First National Bank of Vandalia

432 West Gallatin
Vandalia

ILLINOIS MAIN STREET PROGRAM

Drawn by AMB	June 2008
Project Number 2008023	Sheet 1 of 2

PROPOSED DESIGN

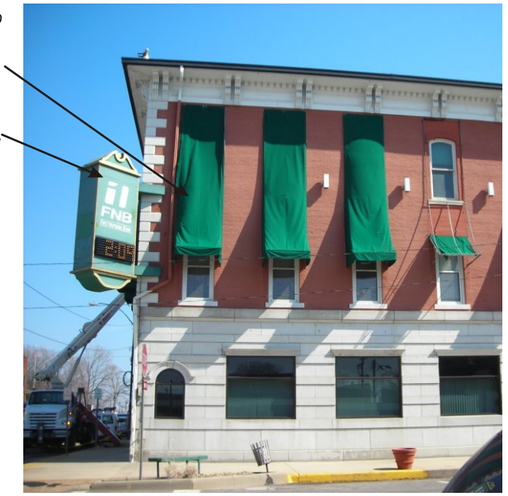
New projecting sign should be mounted in same location as existing sign. Time and temperature sign should be mounted as a separate sign, below the proposed sign.

All existing awnings should be removed from building.

Existing sign should be removed.

Window hoods and small cornice brackets should be painted Nebulous White (SW 7063) from Sherwin Williams Paints or a color that closely matches the stone at the storefront level.

Window sashes, and cornice should be painted Roycroft Bottle Green (SW 2847) from Sherwin Williams paints.

Window trim, large cornice brackets, and molding should be painted Weathered Shingle (SW 2841) from Sherwin Williams paints.

Body of building should be repainted the existing color.

PROPOSED DESIGN

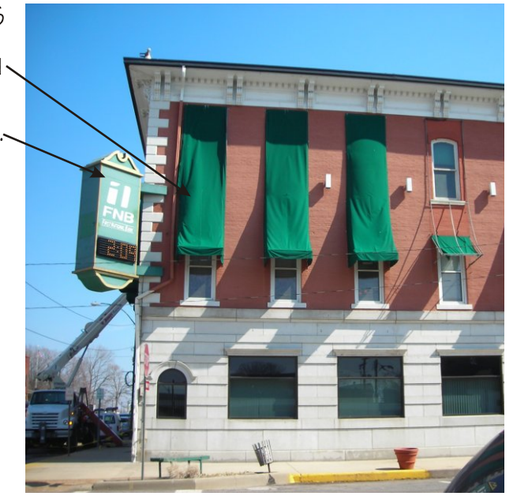
New projecting sign should be mounted in same location as existing sign. Time and temperature sign should be mounted as a separate sign, below the proposed sign.

All existing awnings should be removed from building.

Existing sign should be removed.

Window hoods and cornice should be painted Nebulous White (SW 7063) from Sherwin Williams Paints or a color that closely matches the stone at the storefront level.

Window sashes should be painted Roycroft Bottle Green (SW 2847) from Sherwin Williams paints.

Window trim should be painted Weathered Shingle (SW 2841) from Sherwin Williams paints.

Body of building should be repainted the existing color.
